FIG. 1

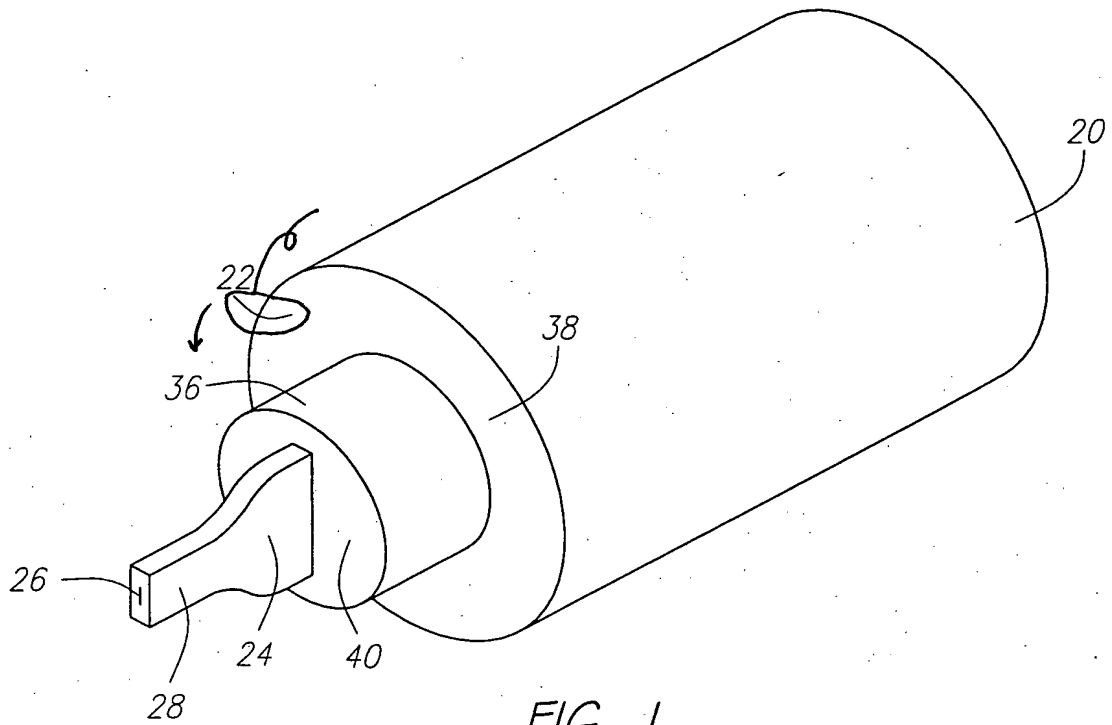
In the office action mailed February 13, 2003, the Examiner objected to Figure 1, stating that the lead line for element "22" is not pointing to the valve support. In addition, the Examiner objected to the disclosure because the first paragraph of the disclosure does not include a reference to the priority application. The Examiner rejected claims 25-27 and 31-33 under 35 U.S.C. §112, second paragraph. Claims 25-27 and 31-33 were also rejected under 35 U.S.C. §102(b) as being anticipated by U.S. Patent No. 5,411,552 to Andersen.

The Examiner objected to Figure 1, stating that the lead line for element "22" is not pointing to the valve support. Applicant has submitted herewith a proposed drawing correction of Figure 1 with revisions to Figure 1 shown in red ink.
